## **Engineering Assessment Report**

Proposed Amendment Application at Tinahisk, Arklow, County Wicklow.

**Client Name:** Castlethorn  
**Document Reference:** 26-035r.006 Engineering Assessment Report  
**Project Number:** 26-035

Figure 6.3 Visibility at pedestrian crossings

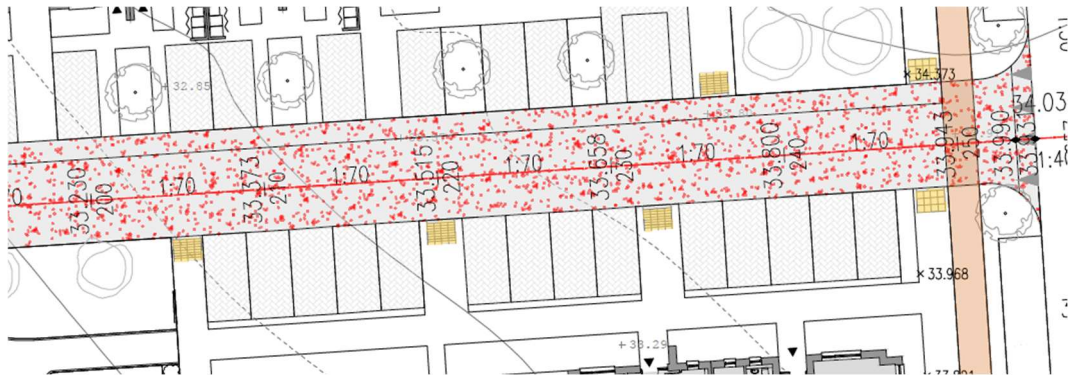
Proposed pedestrian crossing located adjacent to parking bays may obscure drivers' visibility of pedestrians on the crossings, particularly if high sided vans are parking in the spaces, leading to collisions between pedestrians and vehicles.

Figure 6.4 Pedestrian desire line

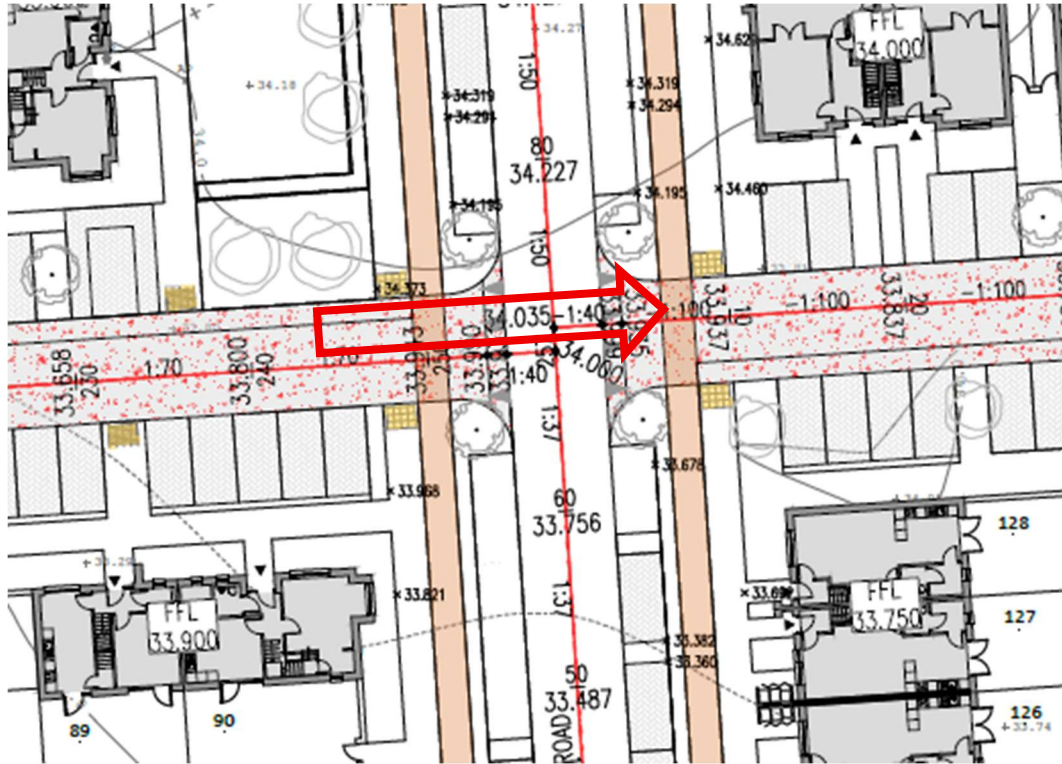
No pedestrian crossing has been provided on the pedestrian desire line illustration below which may lead to slips and trips and collisions between pedestrians and vehicles.

Figure 6.5 Pedestrian desire line

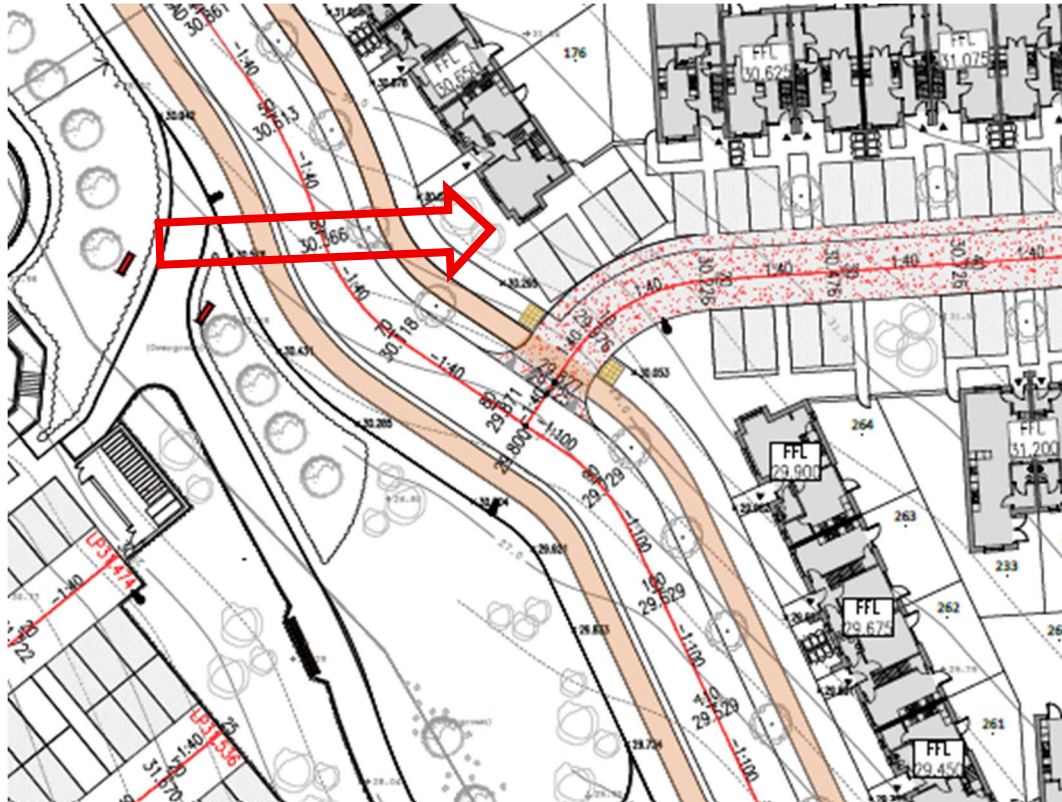
No pedestrian crossing has been provided on the pedestrian desire line illustration below which may lead to slips and trips and collisions between pedestrians and vehicles.

Figure 6.6 Cycle connectivity

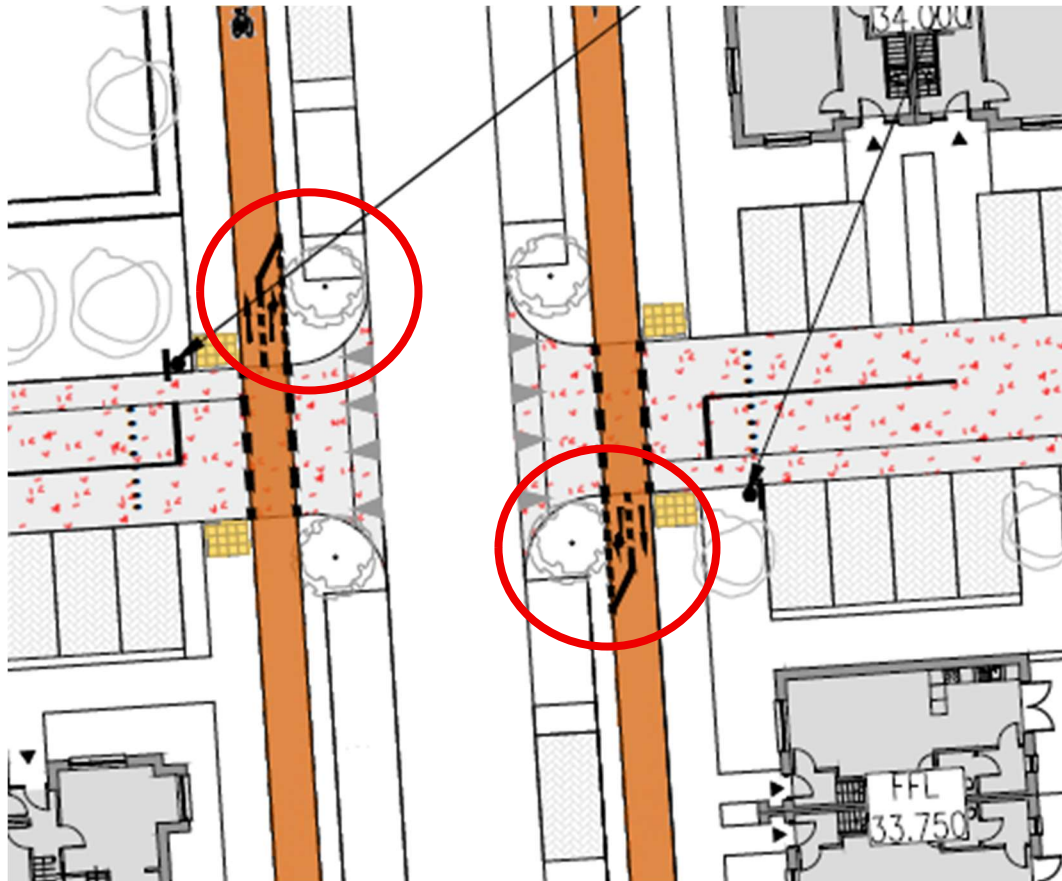
Both trees and parking bays conflict with the proposed cycle routes through a number of junctions throughout the scheme. There is a risk of conflict with vehicles and unsafe surfaces for cyclists to cross.

Figure 6.7 Visibility at pedestrian crossings

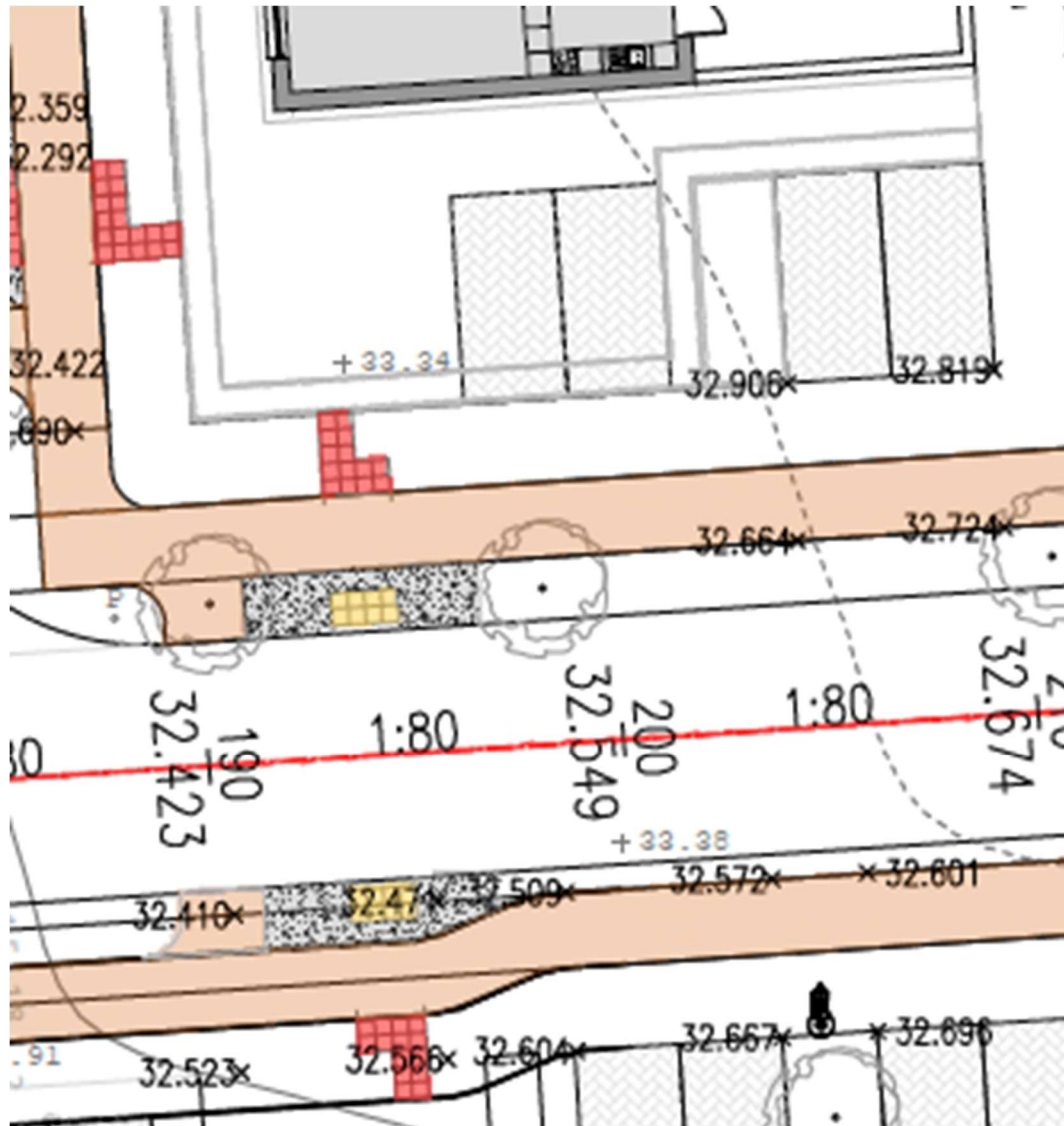
Trees have been proposed adjacent to pedestrian crossings within the development. As the trees mature, they may obstruct visibility between pedestrians and approaching drivers, increasing the risk of vehicle-pedestrian collisions.

Figure 6.8 Cycle connectivity

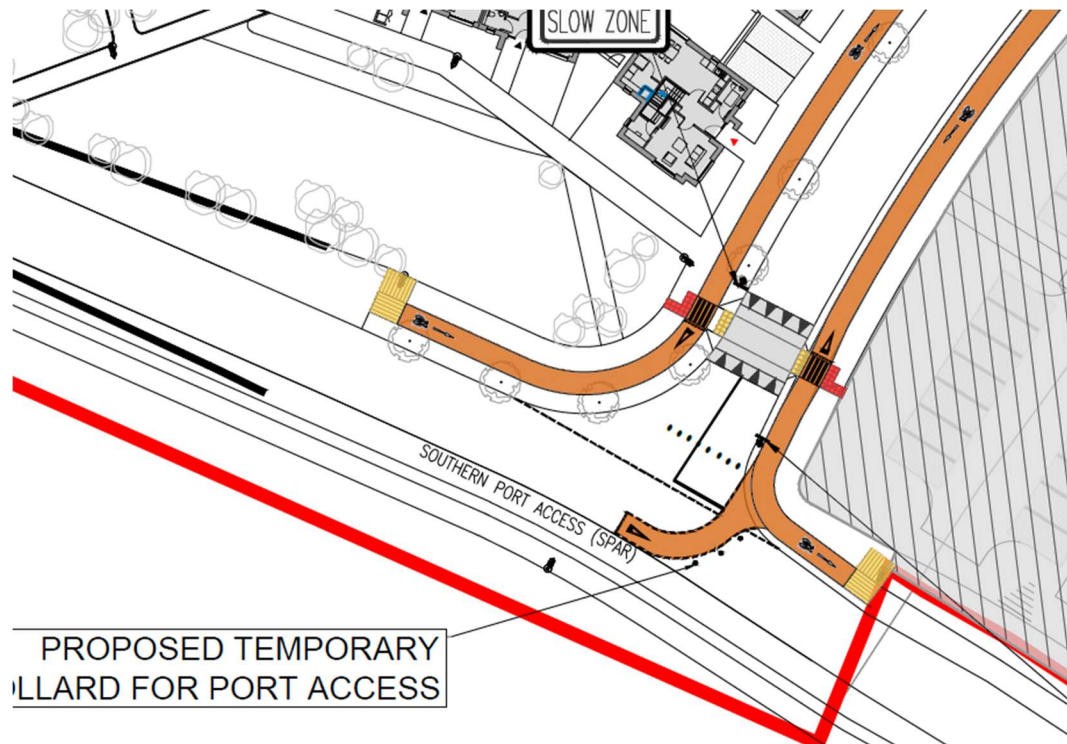
It is unclear whether cyclists travelling straight through on the Southern Port Access Road can access the proposed shared surface on the left-hand side of the road. Where cyclists are required to transfer from the carriageway to the shared surface, no clear means of access has been provided, which may result in cyclists attempting to mount the kerb. This creates a risk of cyclists losing control and falling.

Figure 6.9 Cycle connectivity

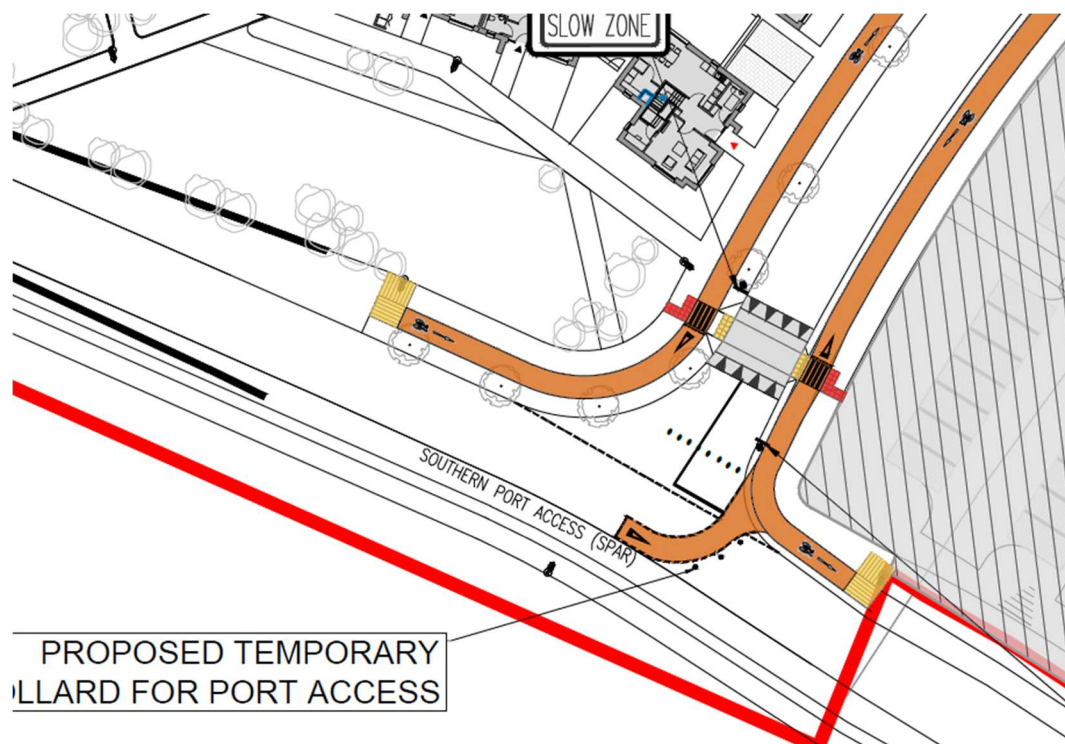
Cyclists exiting the scheme will continue towards the yield point, while vehicles are intended to stop at the stop line. However, as the Southern Port Access is currently closed to vehicular traffic by bollards, drivers may be less likely to stop at the designated stop line and may instead continue around the bend. This could result in vehicles and cyclists merging at the same location, with cyclists travelling along the vehicle's left side.

The resulting arrangement may give rise to restricted intervisibility between cyclists and drivers, particularly where either road user does not yield or stop at the designated location. This could increase the potential for conflicts or collisions between cyclists and vehicles, as well as conflicts with pedestrians in the vicinity.

The cycle arrangement at the junction should be reviewed to provide greater separation and protection for cyclists from vehicles, while ensuring that both cyclists and drivers have adequate intervisibility when merging.

Figure 6.10 Junction visibility

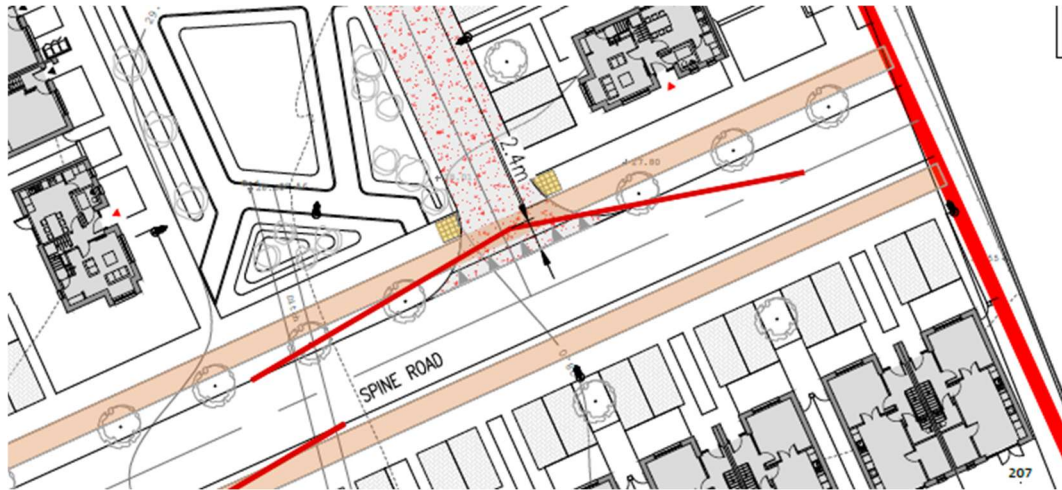
A number of trees have been proposed within the visibility splays of junctions. As these trees mature, they may obstruct visibility for drivers approaching or exiting the junctions, increasing the risk of conflicts and collisions with vehicles travelling along the mainline.

Figure 6.11 parking conflict

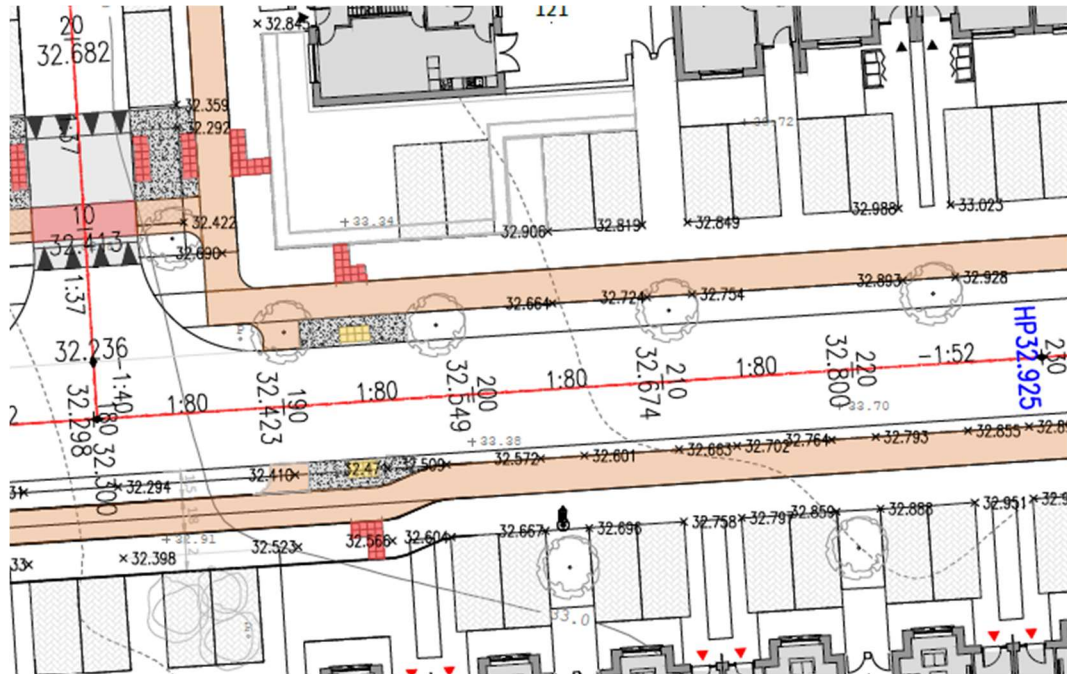
Trees have been proposed directly within and immediately behind parking bays throughout the development. This creates a risk of vehicles colliding with the trees, potentially resulting in material damage to vehicles and damage to the trees.

Figure 6.12 Spine road speed

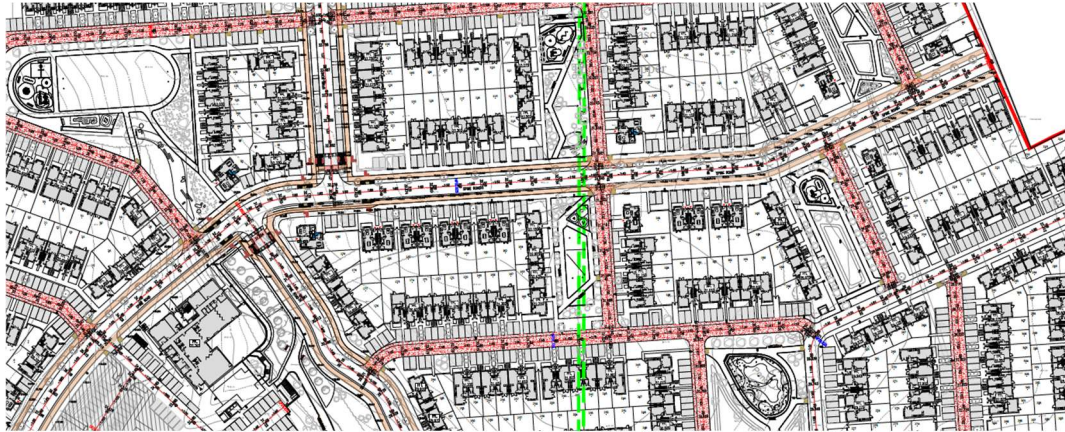
Long, straight sections of road with limited traffic-calming measures have been proposed within the scheme. The road layout may encourage higher vehicle speeds, increasing the risk of collisions, particularly given the high number of vulnerable road users within the development.

Figure 6.14 Tactile Paving Arrangement

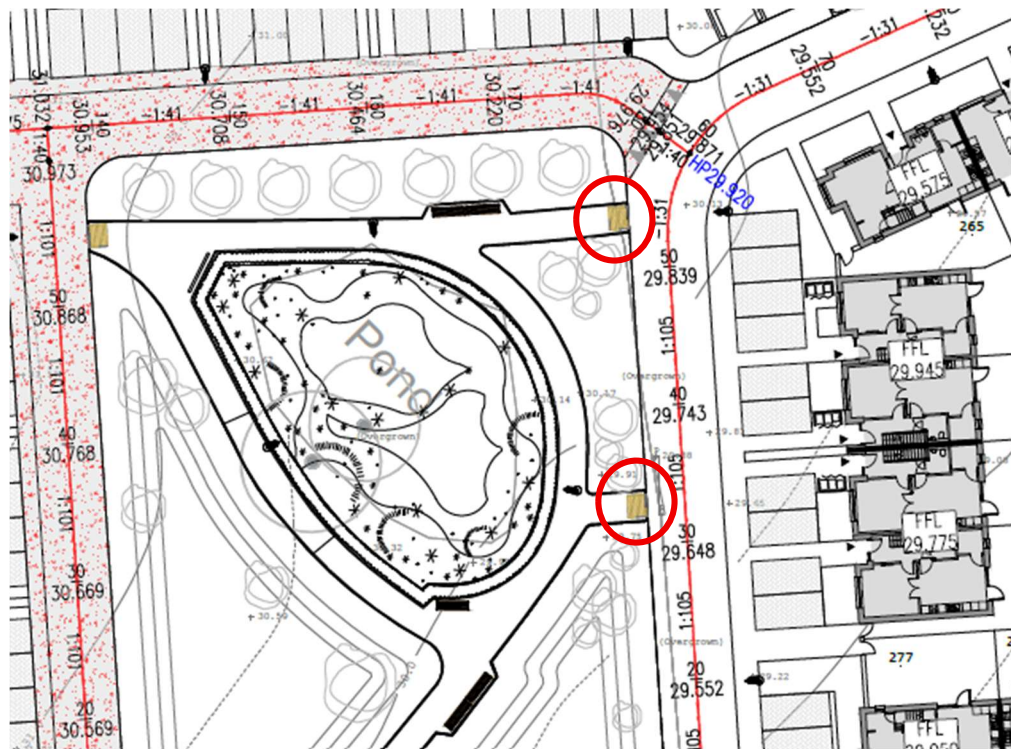
At a number of pedestrian crossings within the scheme, tactile paving has only been provided on one side of the road. This may cause confusion for visually impaired pedestrians and may result in pedestrians crossing at inappropriate or unintended locations, increasing the risk of collisions with vehicles and slips and trips.

### 1.3 Observations: EV parking bay sizes

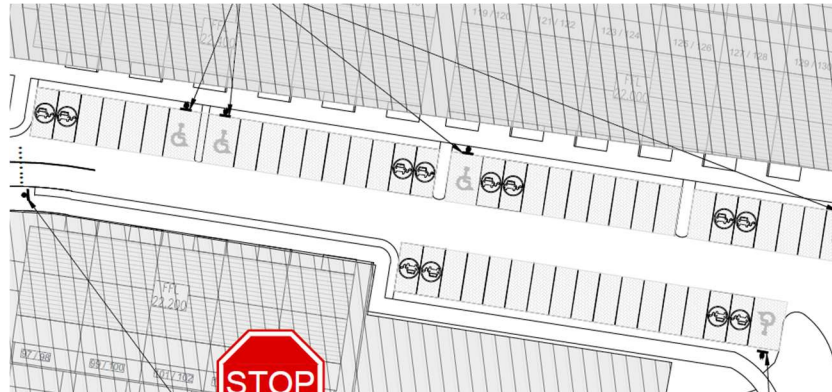
EV parking bays have been detailed to the same dimensions as standard parking bays. The available width may be insufficient to allow convenient access and egress from vehicles, particularly where charging cables are required. This may increase the risk of material damage to vehicles and create difficulties for mobility-impaired users accessing or using the EV charging facilities.
